AGENDA

October 15, 2013

Planning Board Meeting

DATE: SEPTEMBER 13, 2013 JOB NO. 0770
SHEET 1 OF 1 FIELD BOOK & PAGE: 280-45

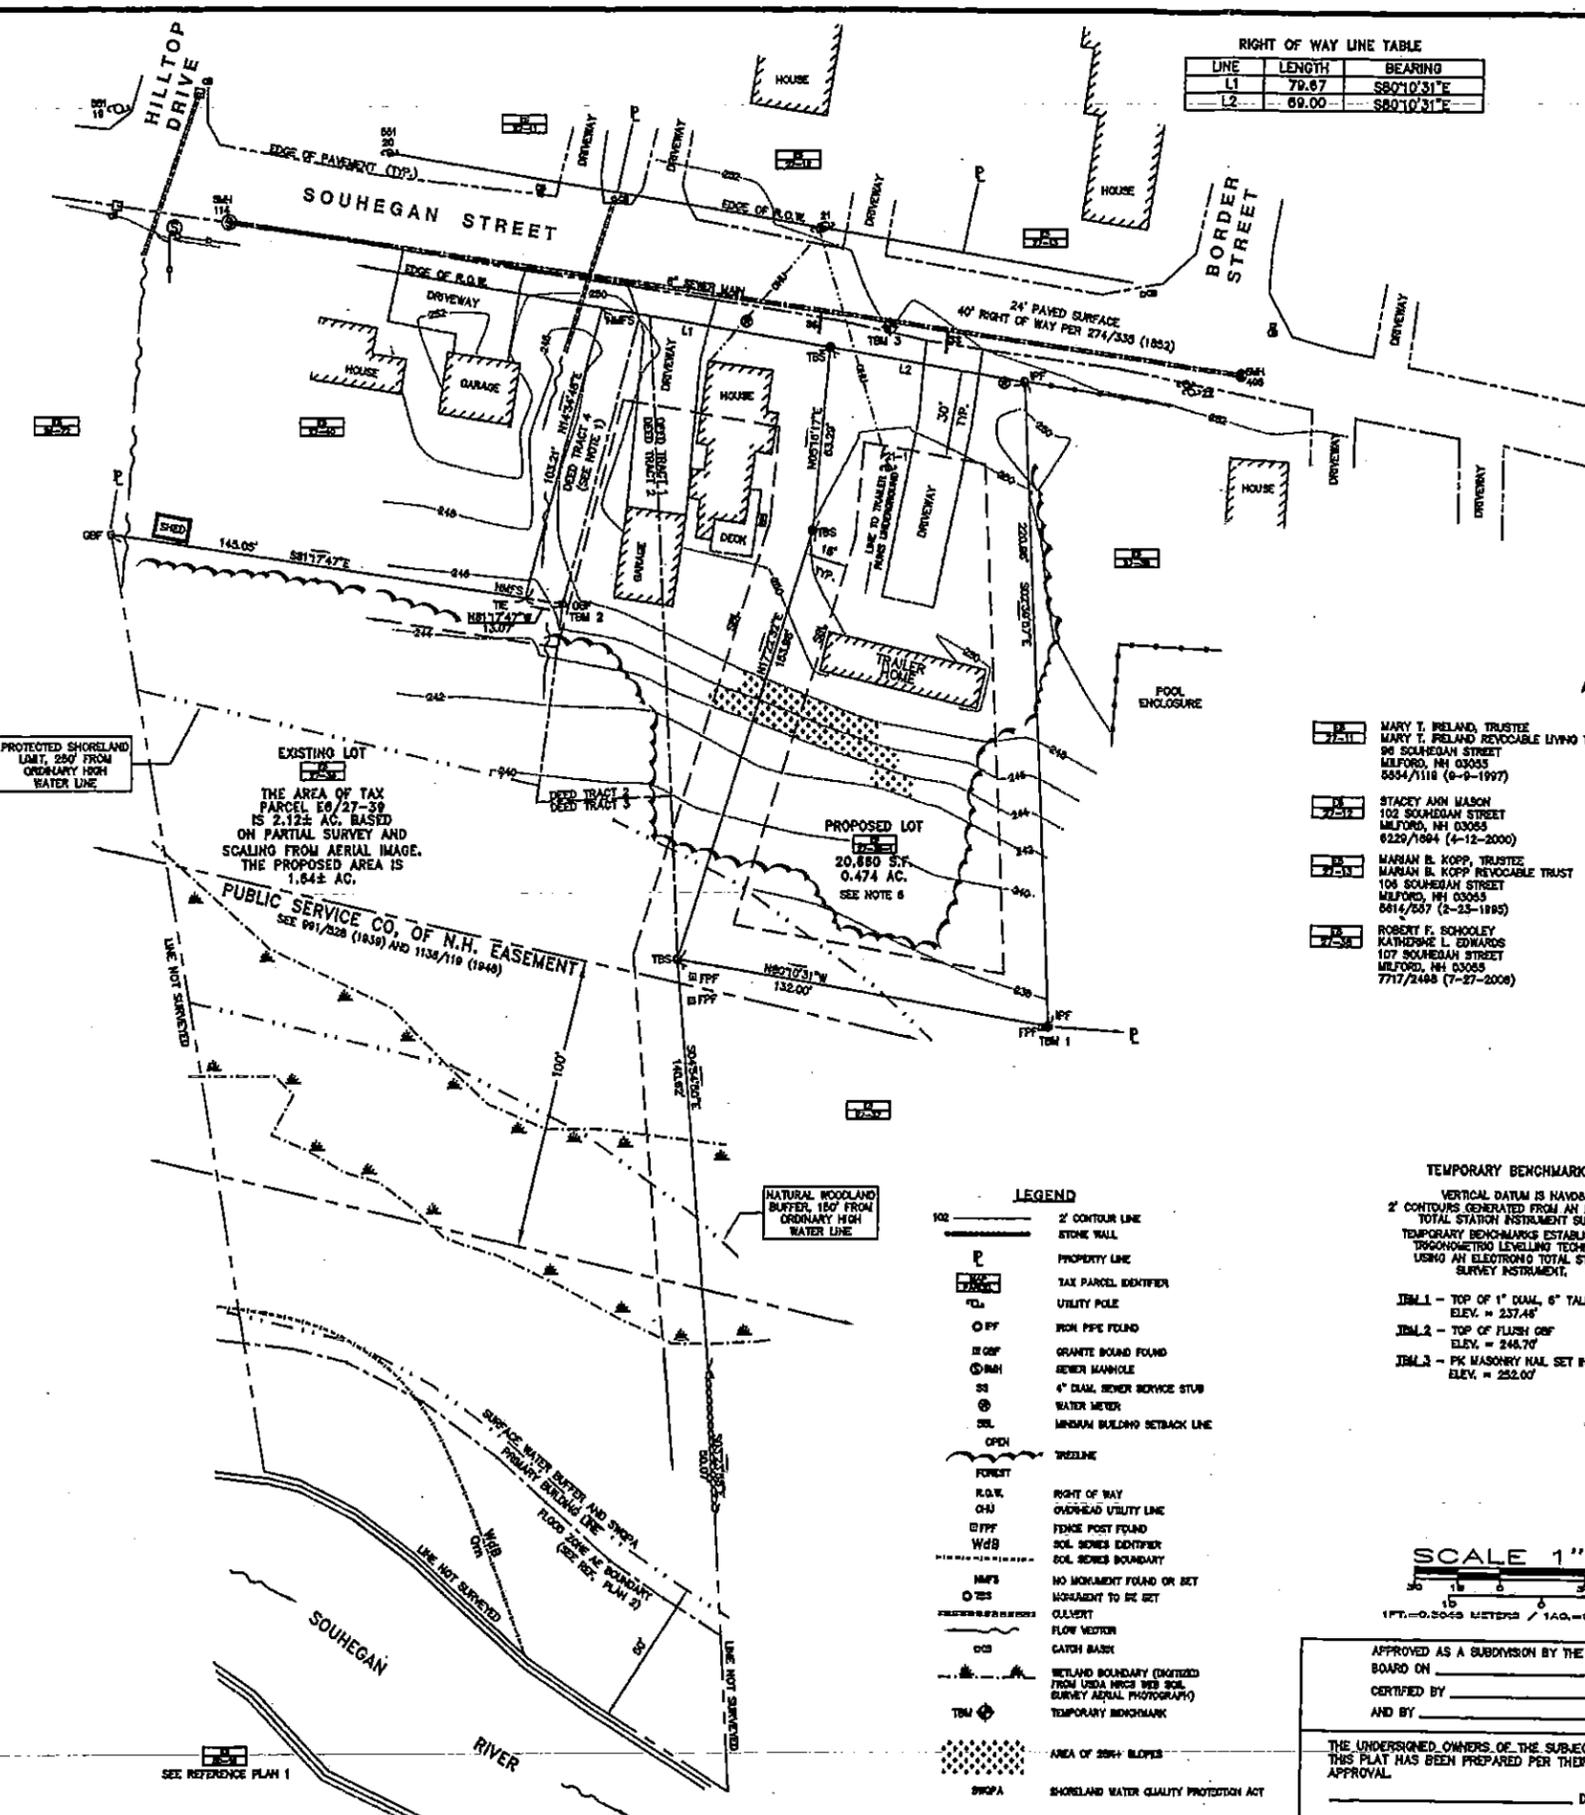
Staff has no issues with the proposed minor subdivision. The Board should first act on the three waiver requests for wetlands delineation, areas of 25% slopes or greater and property lines. If the Planning Board approves the application The Planning Department recommends that the following conditions are met prior to final signing:

1. All property monumentation be set on site and noted on the plan prior to recording of the plan;
2. All occurrences of Map E6 shall be removed from the plan and parcel number should read as Map 27 Lot 39;
3. A note be added to the plan referencing all approved waiver requests (if applicable);
4. Location of flood zone and location of the shore land protection district boundaries shall be shown on the plan;
5. A note stating that the property lies within the Level 1 Groundwater Protection District;
6. A note stating that the property lies within the Shoreland Protection District;
7. A note stating Flood Zone information;
8. Water lines serving the existing dwelling units be shown on the plan;

Section 5.06 I This section calls for property lines with bearings and distances. Proposed Lot 27-39-1 has been surveyed and the lot is shown with bearings and distances. The developed portion of the remaining existing Lot 27-39 has been surveyed, and all pertinent boundary evidence and monumentation has been surveyed. All this information is shown on the plan. The un-surveyed lines of portions of Deed Tract 3 are taken from the Milford Tax Map and are represented on the plan in a manner that I trust is sufficient for the Board's deliberations. I request a waiver for providing bearings and distances on all property lines.

Section 5.06K This section requires showing wetlands delineated by a Certified Wetland Scientist and wetland buffers on the plan. Because the proposed project involves no further development, rather than delineated wetlands, we have provided wetland boundaries digitized from an aerial photo obtained from the NRCS Web Soil Survey website. This gives a fairly accurate picture of the wetland feature of the lot relative to existing development. There are no wetlands on proposed lot 27-37-1 or in the vicinity of the existing development on both proposed lots. I request a waiver for the requirement to provide delineated wetlands and wetland buffers. Accordingly, the plan is not stamped by a Certified Wetland Scientist.

Section 5.06L This section requires showing areas of 25% slopes. Two-foot contour line elevations and 25 % slopes, based on an actual survey, have been shown on the proposed new Lot 27-39-1. Since development on both proposed lots is existing and established, we have not shown elevations on the remainder lot. I request a waiver for the requirement to provide delineated 25% slopes on the remainder Lot 27-39.

OPEN SPACE SUBDIVISION PLAN
TAX MAP PARCELS 47-5, 47-5-1 & 47-6
137 & 131 MELENDY ROAD
MILFORD, NEW HAMPSHIRE
LAND OF
CREATIVE INVESTORS
P.O. BOX 424 MILFORD, NH 03055

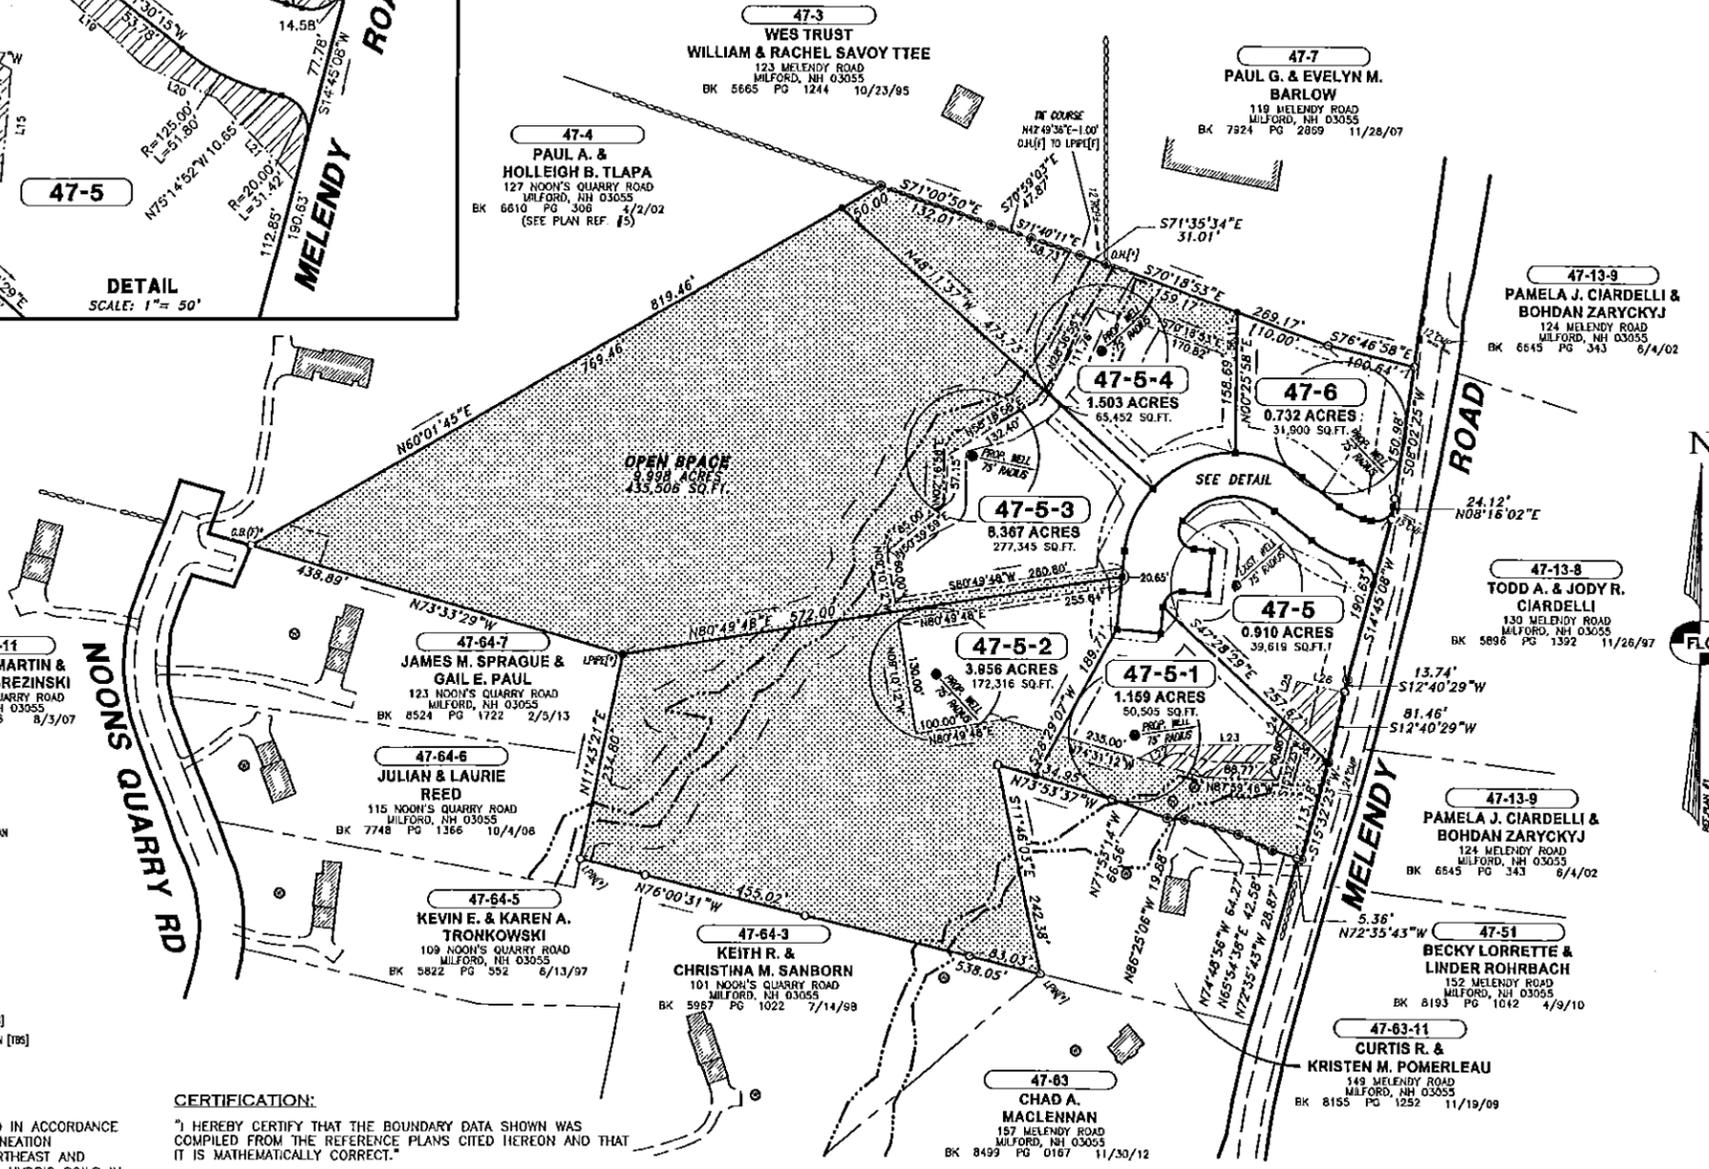
Driveway locations are not currently displayed on the subdivision plan. All locations of proposed driveways shall be submitted for review and inclusion in the final plan set. All driveways will require permit approval from the Department of Public Works at the time a building permit is applied for. All driveways must be designed and constructed per the Town's Residential Driveway Regulations. At no time shall driveways be designed to drain into the Town right-of-way and/or the home owner's house such as the garage or basement.

Per section 5.08 of the Development Regulations the applicant needs to specify how the open space lot (Map 51, Lot 3) will be owned. Their options are: a government agency or nonprofit; in common by 6 residential lots; a homeowners association of the 6 residential lots; or the land may remain with the developer. If the applicant would like to propose some other form of ownership of the open space they will need to seek Planning Board approval.

1. Notes indicate utilities will be both underground and above ground. Please clarify.
2. Grading of driveways should be shown, at least on steep lots.
3. Test Pit data should be provided.

1. Flatten out top of hammerhead and extend road a tad further for proper snow storage
2. No provisions for DPW access to second drainage pond- how will these be maintained?
3. What are dotted/hatched lines representing in catch basin area?;
4. Concerned with the ditches on both sides of road- guardrails should be installed;
5. Issues with the 20 foot wide road—would like to see 24 feet;
6. Are under drains needed? Need detail for under drain outlets;
7. Would like to see a minimum of 15 foot driveways;
8. Pipe crossing the bottom of Ball Court HWI/HWZ is shown as 12”- the town standard is 15” minimum;
9. The 15” CMP pipe on Melendy Road should be checked for the condition and possible replacement- connecting a new pipe to an old may not function correctly;

1. Properties are zoned Residence ‘R’ and is proposed to be developed as an open space subdivision.
2. The three existing lots are proposed to be combined and re-subdivided into six single-family lots.
3. No issues relative to zoning as long as the project meets the criteria specified in Article VI, Section 6.04.0 Open Space and Conservation District.
4. Would recommend that Note #5 on Sheet 1 of 6 be revised to add the following (revisions in bold):
“Provided open space: 435,506 sq.ft. total provided (65.8% of site) of which 276,956 sq.ft. = non-wet & non steep slopes (41.9% of site which exceeds the required non-wet and non-steep slope requirement by 101%)”
5. Would recommend a note be added to the plan that states all lot monumentation to be set prior to the signing of the subdivision plan or a security be provided to the Town to cover the cost of monumentation.

1. In coordination with Town Staff, investigate alternative stormwater control measures and revise plan set as necessary;
2. A note be added to the plan that states prior to the issuance of a final certificate of occupancy (C.O.) a letter from a licensed surveyor be submitted to the Building Department attesting that all lot monumentation has been set.
3. A note be added to the plan stating that all utilities shall be underground- Notes currently indicate utilities will be both underground and above ground.
4. Include proposed driveway locations on final plan set;

5. All state permit approval numbers and expiration dates be added to the notes section as necessary;
6. Delineation of all proposed easements; inclusive but not limited to utility, drainage, access, conservation, open space, slope etc;
7. All applicable easement documentation be submitted to the Town of Milford;
8. Note #5 on Sheet 1 of 6 be revised to add the following
 “Provided open space: 435,506 sq.ft. total provided (65.8% of site) of which 276,956 sq.ft. = non-wet & non steep slopes (41.9% of site which exceeds the required non-wet and non-steep slope requirement by 101%)”
9. Add a note indicating the ownership of the open space. If the open space will be owned by a nonprofit organization, in common by the 6 residential lots or by a homeowners association, all necessary legal documentation will need to be submitted for recording with the final subdivision plans.

ROADWAY PLAN & PROFILE
- STA 0+00 TO STA 4+50, BALL COURT -
TAX MAP PARCELS 47-5, 47-5-1 & 47-8
137 & 131 MELEUDY ROAD
MILFORD, NEW HAMPSHIRE
LAND OF:
CREATIVE INVESTORS
P.O. BOX 424 MILFORD, NH 03055

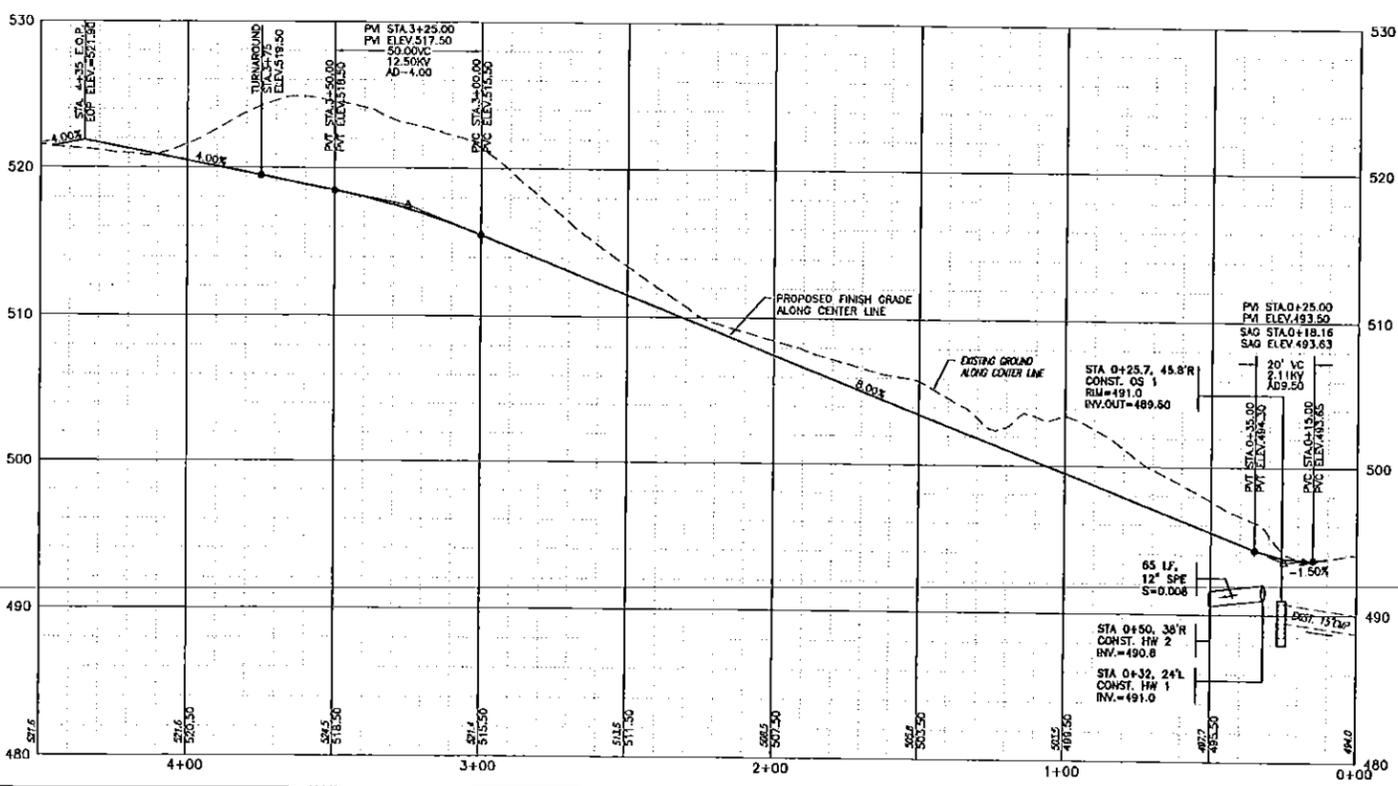
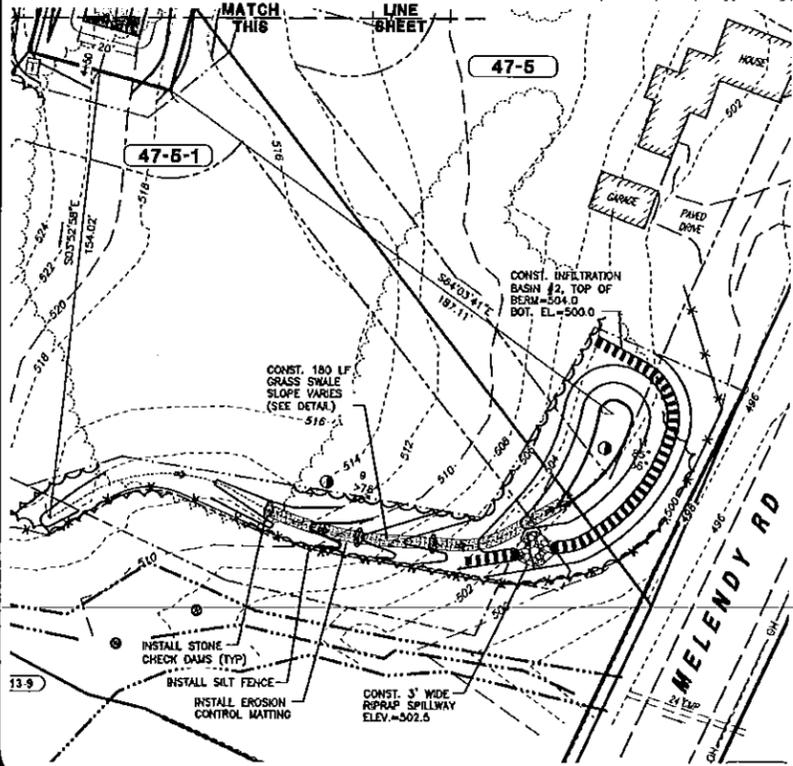
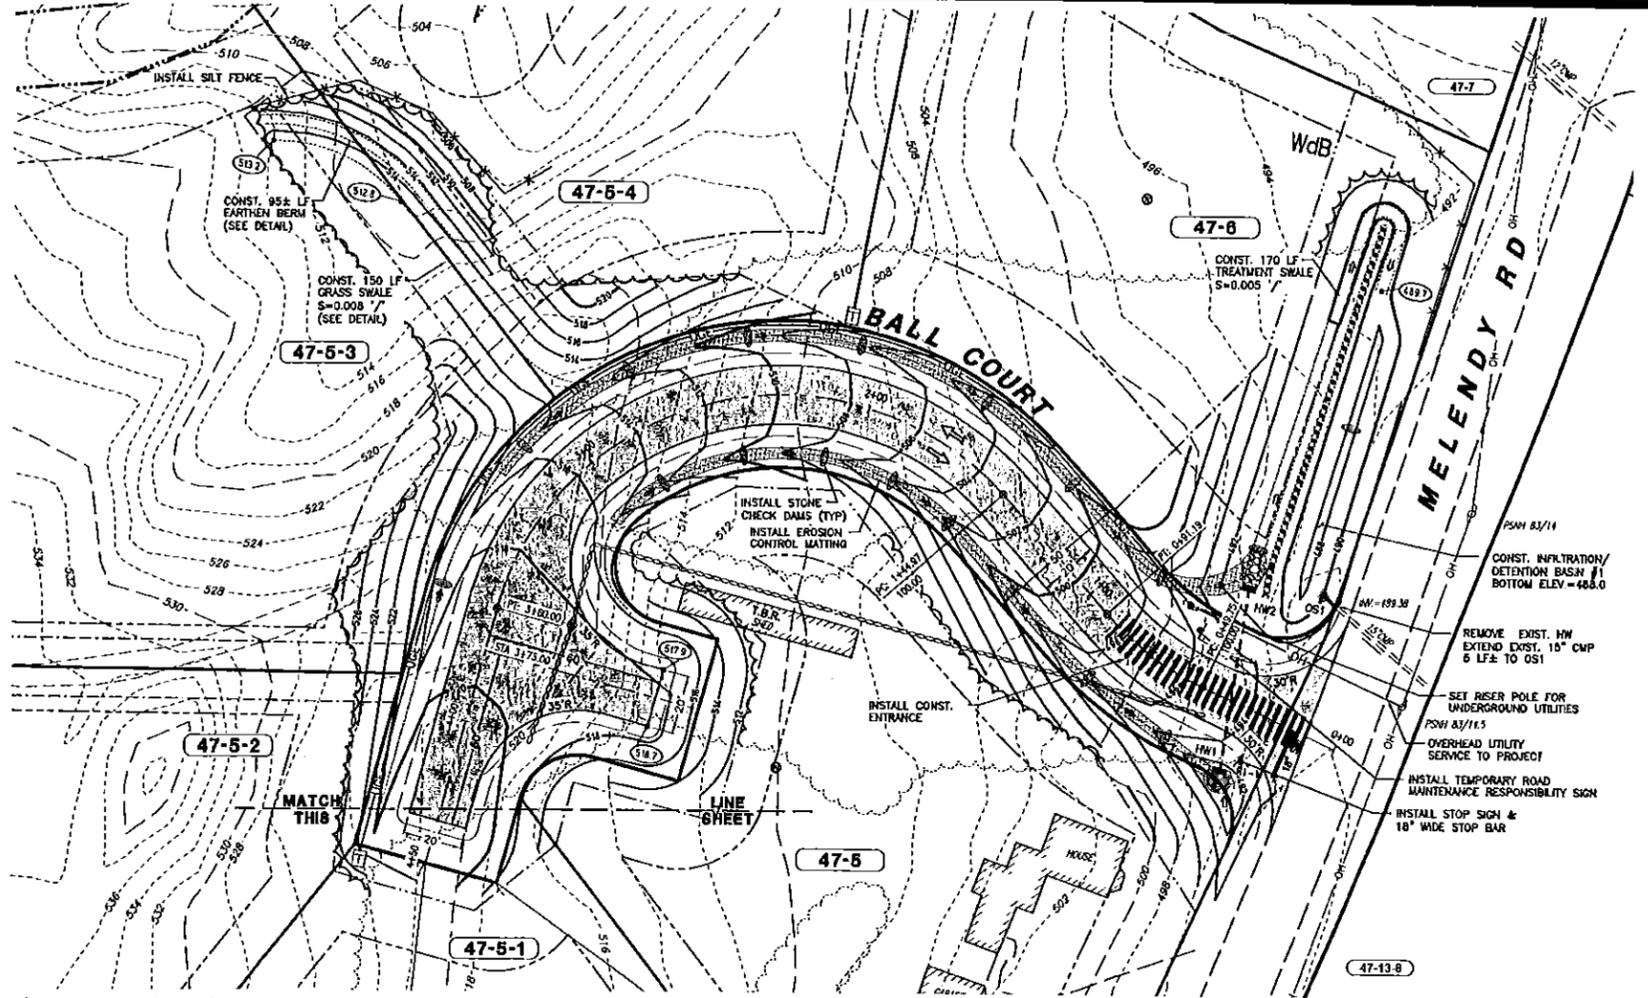
The drainage system has been designed to collect stormwater from the roadway. The proposed road is cut into a small ridge on the property. The proposed road directs runoff to flow towards the street either by sheet flow or the open ridge on the property. The road runoff is directed to a treatment swale followed by an infiltration/detention area prior to discharge to an existing cross culvert in Melendy Road. A swale is proposed along the lot line between lots 47-5-3 and 47-5-4 to reduce the runoff flowing northerly from lots 47-5-2 and 47-5-3. A second infiltration basin is proposed in the southeast corner of the property to mitigate the runoff flowing southeast from lots 47-5-1 and 47-5-2. A swale is proposed along the wetland buffer adjacent to the southerly property line to direct stormwater runoff to the basin on the northeasterly portion of the property. This swale will direct the runoff to another infiltration basin located in the southeast corner of the property.

Building Department: Will have to change the street name. Ball Court is too similar to Ball Hill Road.
